# Work Order ID 87323

Item ID: D212-664-101F Accept \*N900040100\* Setup Start \*NS1\*  
 Revision ID: Stop \*NS2\*  
 Item Name: Crosstube Fwd  
 Start Date: 7/10/12 Start Qty: 1.00 \*1\* Cust Item ID:  
 Required Date: 7/27/12 Req'd Qty: 1.00 \*1\* Customer:  
 Reference:

DRAWING NO. D212-664-141	TITLE XTUBE ASSY (205/212/412 HI FWD)	REV. D	DART AEROSPACE LTD ENGINEERING ORDER		D.E.O. NO. D212-664-141-D-1	SHEET NO. SHEET 1 OF 2	SCALE NTS
DRAWN	CHECKED	MFG. APPR.	APPROVED	DE APPR.			
DATE 11.04.07	DATE 11.04.11	DATE 11.04.12	DATE 11/04/12	DATE 11.04.12

DRAWING NO. D212-664-141	TITLE CROSSTUBE ASS'Y (205 HI FWD)	REV. D	<b>DART AEROSPACE LTD ENGINEERING ORDER</b>		D.E.O. NO. D212-664-141-D-2	SHEET NO. SHEET 1 OF 1	SCALE NTS
DRAWN <i>UP</i>	CHECKED <i>ADS</i>	MFG. APPR. <i>ES</i>	APPROVED <i>MP</i>		DE APPR. <i>TH</i>		
DATE 11.07.15	DATE 11.07.20	DATE 11.07.21	DATE 11/07/21		DATE 11.07.21

**D212-664-141/-141B  
ASSEMBLY DETAIL**

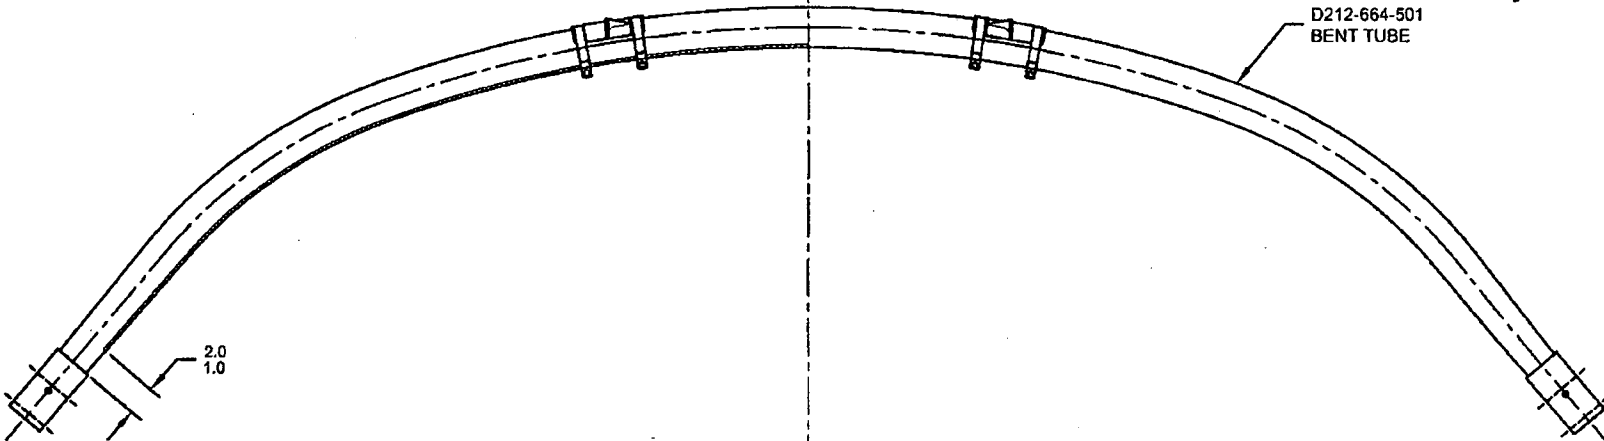
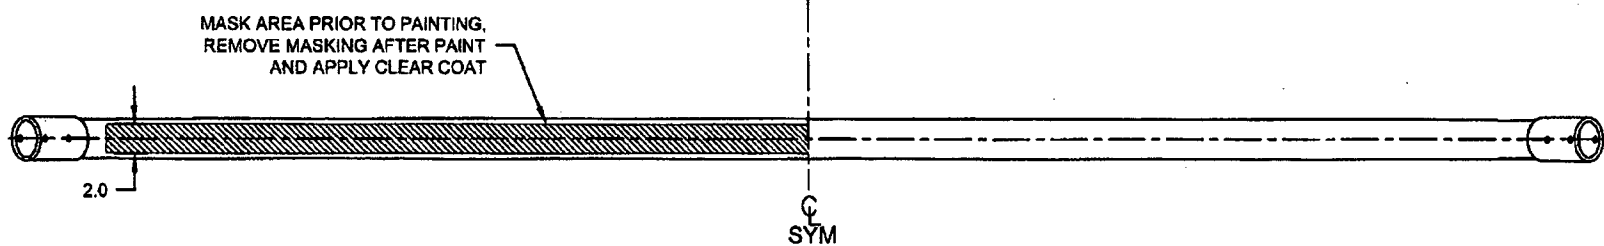
**PURPOSE:**

ADD AN INSPECTION WINDOW TO UNDERSIDE OF CROSSTUBE.

NOTES 2 OF SHEET 1 IS AMENDED AS FOLLOWS:

IS:

WAS:
